October 13, 1995
LIC-95-0180

SUBJECT: Response to Request for Additional Information (RAI) on Proposed Revision to the Safety Evaluation for the Spent Fuel Storage Rerack at Fort Calhoun Station (FCS) Unit No. 1 (TAC No. M91954)

**"Responses to Request for Additional Information
on the Proposed Revision to the Safety Evaluation Report
for the Spent Fuel Storage Reracks"**

Figure 1

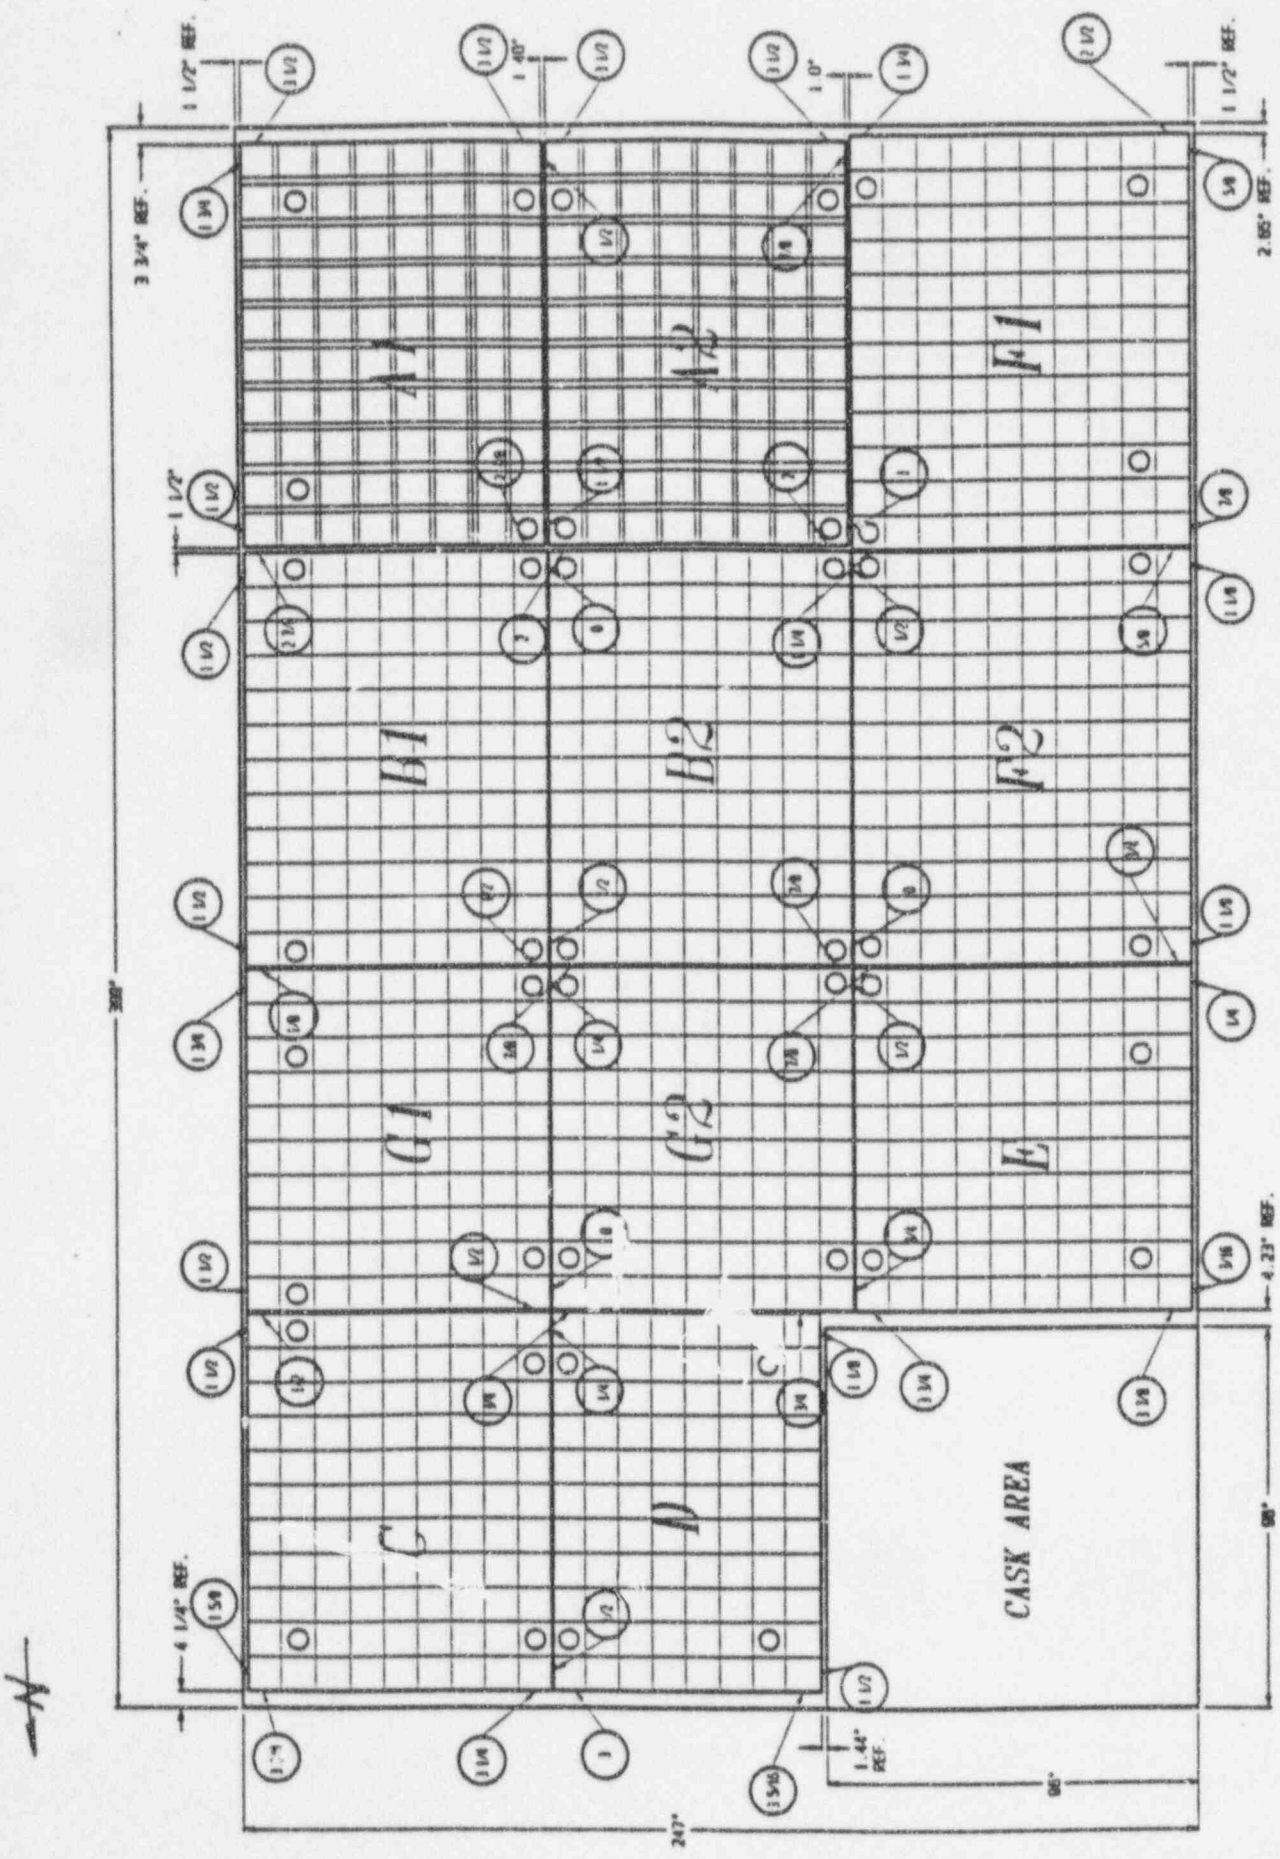
Provide the clearances between the racks and between the racks and the spent fuel pool walls used in the original and re-analysis in a tabular form.

The attached sketch of the FCS Unit 1 pool layout (Figure 1) shows the "as built" rack-to-rack and rack-to-wall gaps as well as the design basis gaps. The "as built" gap measurements are circled in the sketch and were measured from the most protruding points of the bumper bars. The design and as-installed average clearance between racks and between racks and walls (excluding bumper bars) are shown in Table 1.

* The as-installed gap size is taken as the average of two measurements at rack top excluding 3/16-inch bumper bars (see Figure 1). The values in parentheses are the nominal design basis gaps.

STRESS CALCULATIONS

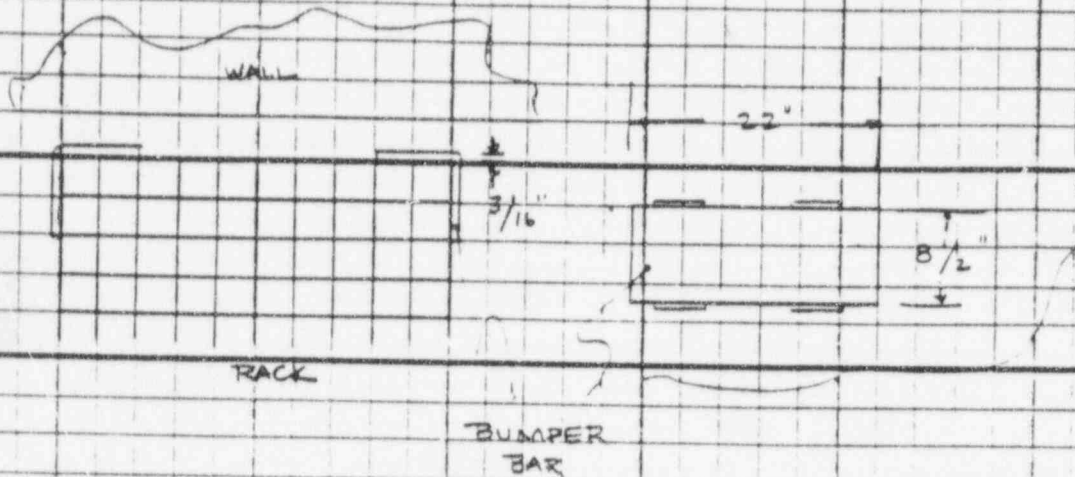
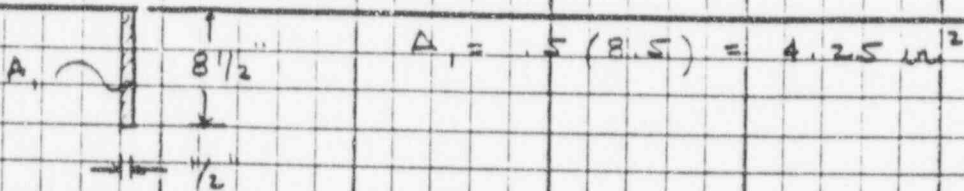
With respect to the fuel pool structure analysis, the original analysis shows the limiting safety margin of 1.03 for a wall (Table 8.5.3 of Reference 1). What is the limiting safety margin of the wall after considering the rack-to-wall impact loads in the re-analysis? Provide the inputs and outputs of the original and re-analysis including any technical assumptions made during the analysis for further staff review.

The following page includes bearing stress calculations for a spent fuel pool wall under maximum impact conditions. The design bearing strength exceeds the calculated maximum rack-to-wall impact.

ASSUME IMPACT OCCURS OVER 1/2" BAND OF BUMPER BAR

$$2\phi (0.85 f'_c A) = 17,701 \text{ lb}$$

THE MAXIMUM BACK-TO-WALL IMPACT AT
BUMPER BAR LOCATION IS 6,813 lbf.
